TK3101- TRACK

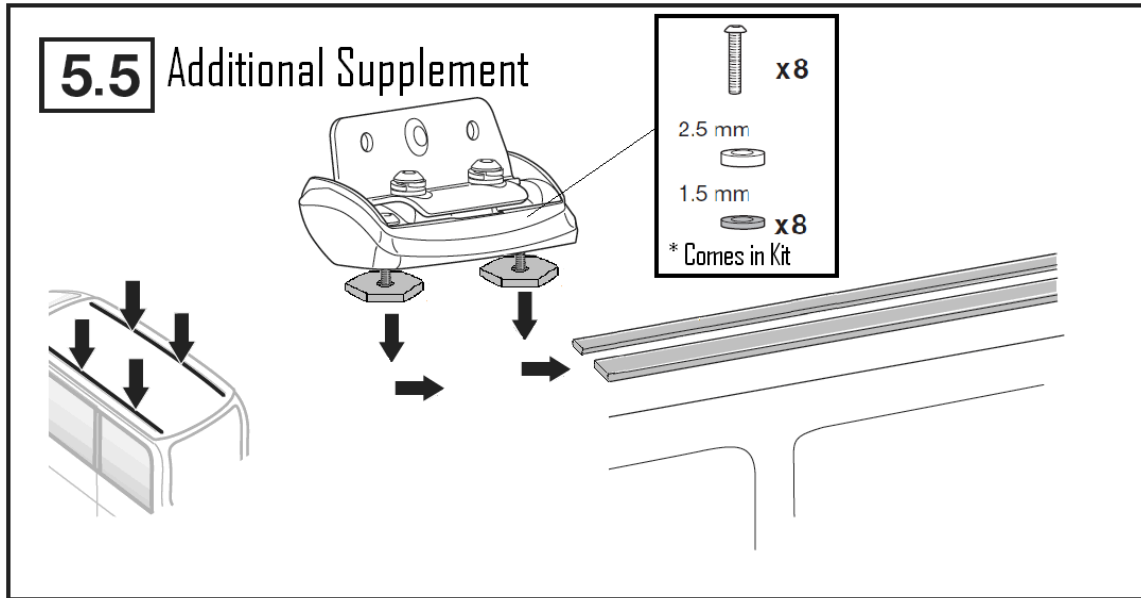
- Please check internal track clearances for the brass hex nuts. May require positioning nuts before installing the track.
- May require removal or additional washers depending on track thickness (1.5mm or 2.5mm or both).
- Please check internal clearance once bolts are tightened.
